**MEMORANDUM**

FROM: *Robert Bricker, REHS/RS, L.E.H.S.*  
Well & Septic Program

RE: *1022 High Stepper Trail*, Potential Basement Bedroom

I have reviewed the floor plans in support of Building Permit **B20000228** for a new home at **1022 High Stepper Trail** and noted that there is a full bathroom planned in the finished basement. Please note that this makes it very likely for at least one more room to be considered a bedroom should the basement layout be modified and/or an egress window installed.

**BASEMENT FLOOR PLAN**  
 A-6 SCALE: 1/4" = 1'-0"

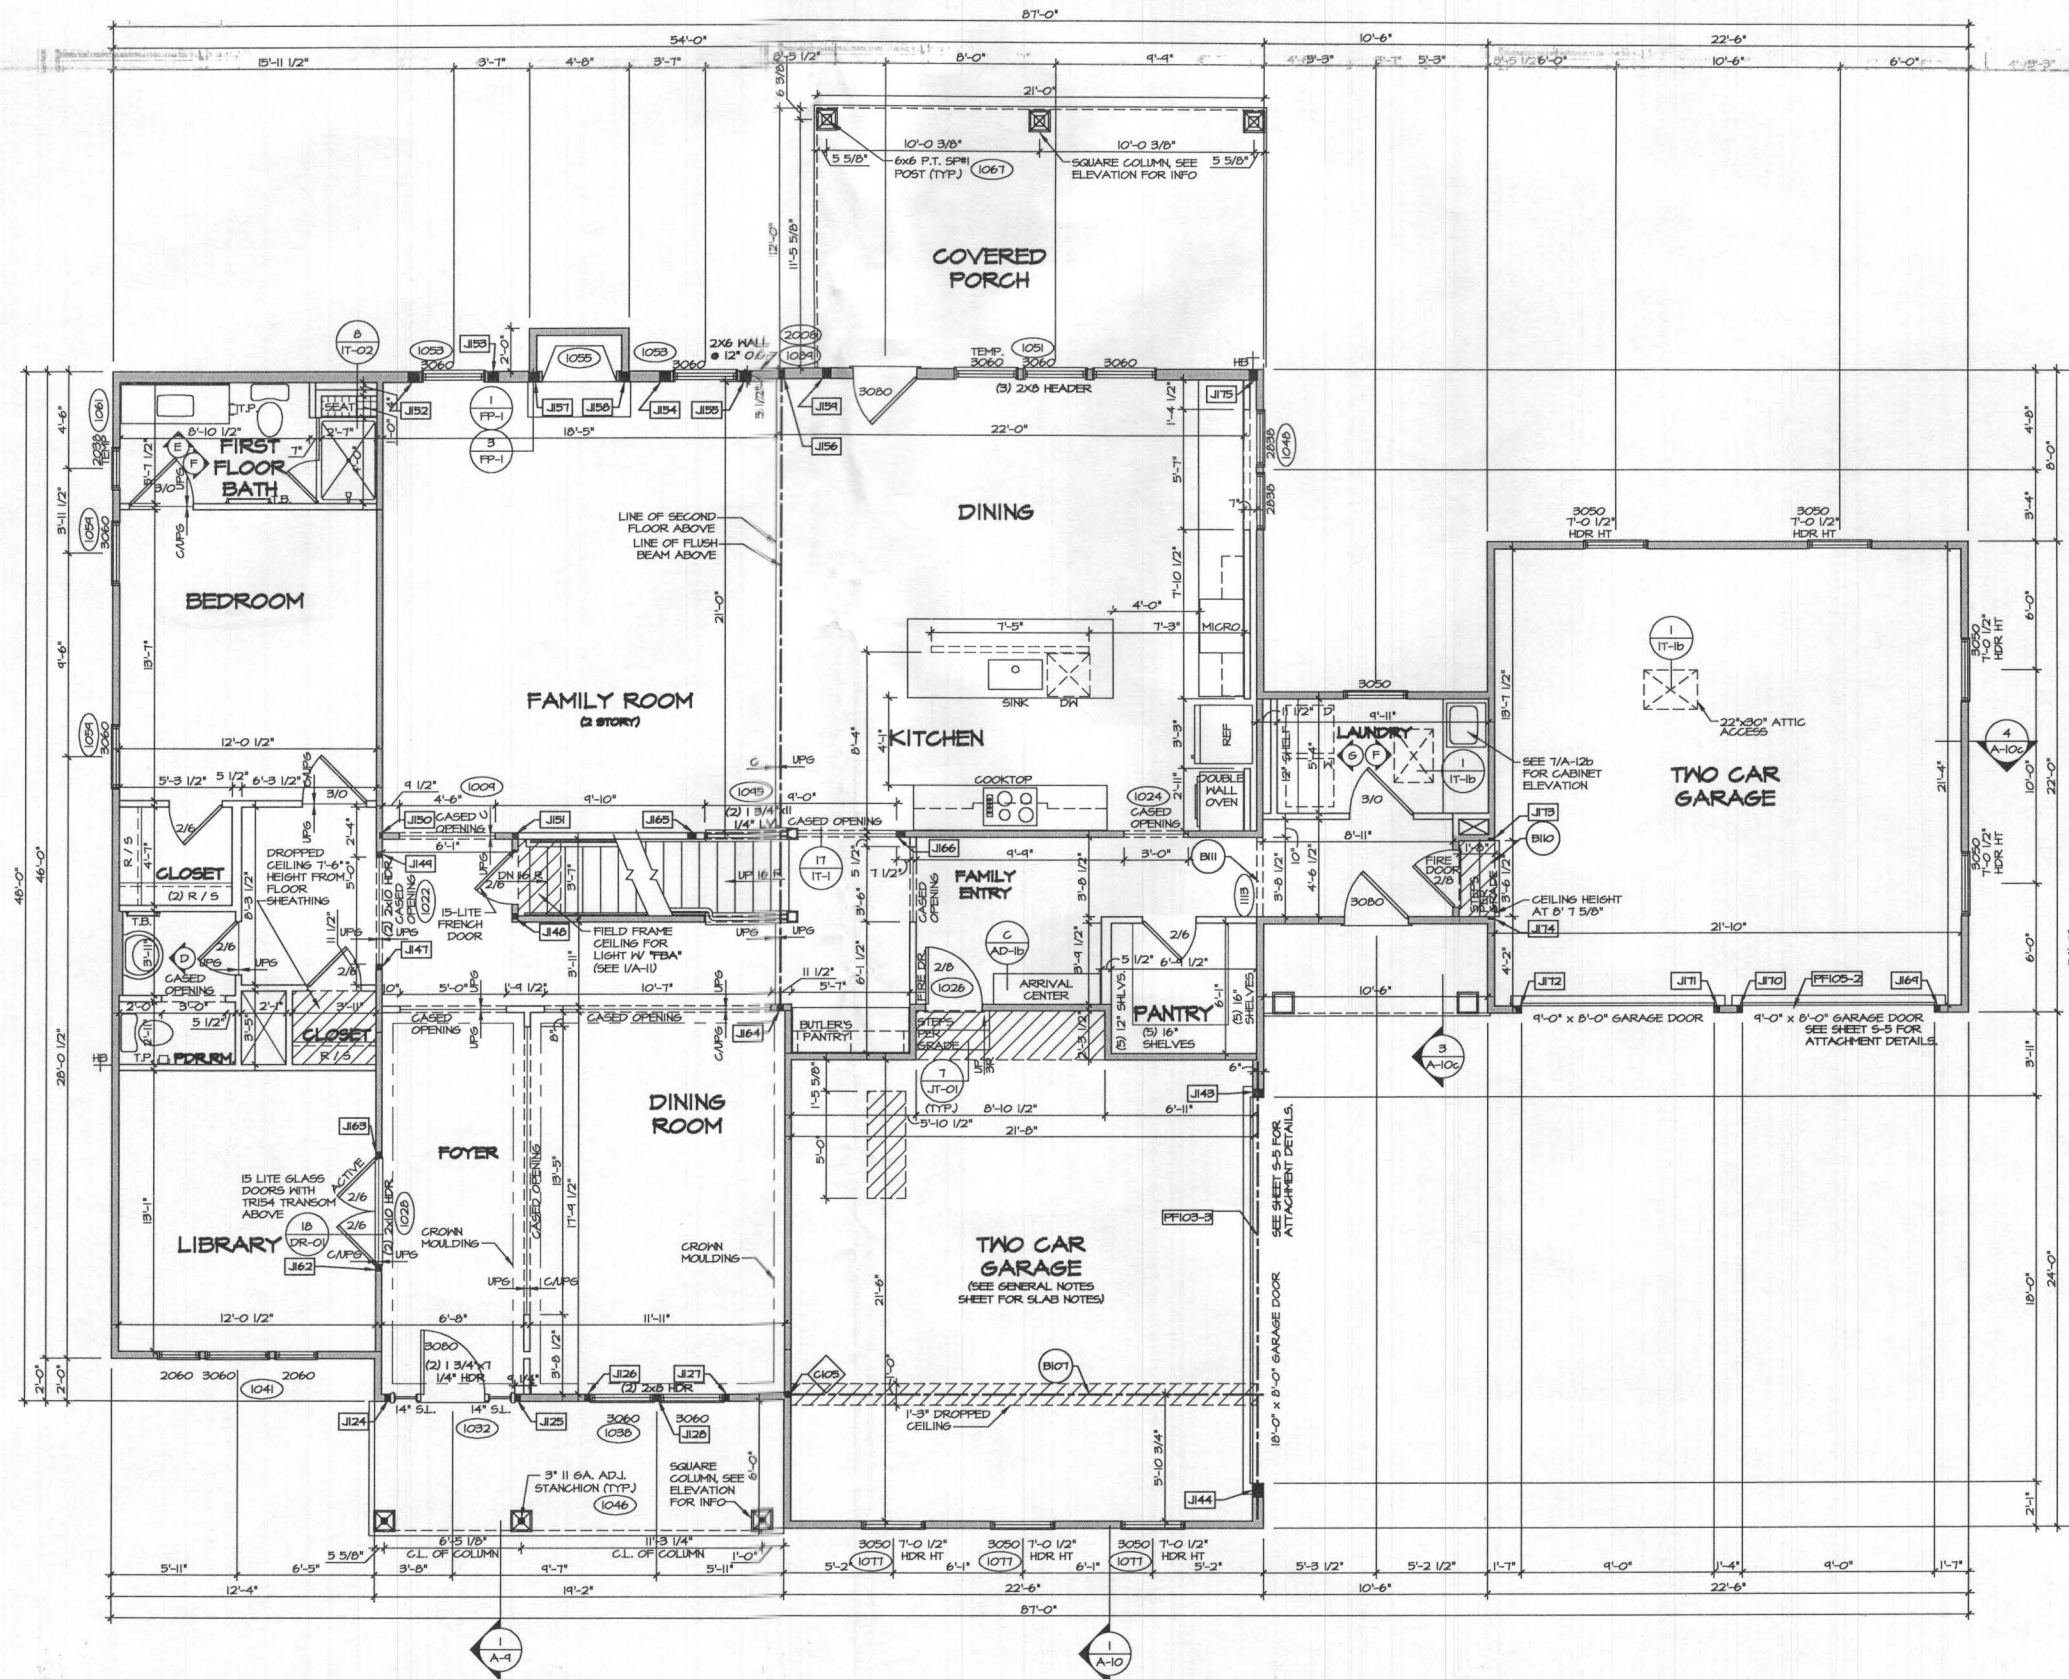
The Health Department strongly recommends sizing the onsite sewage disposal system at least one bedroom larger than the existing **five (5)**- bedroom design to accommodate a future modification of the finished basement. If you choose to only size for the existing design, any future building permit for modification of the finished basement may be placed on hold until the system is upgraded to accommodate the proposed number of bedrooms. This memo will be retained in the Health Department file for future reference.
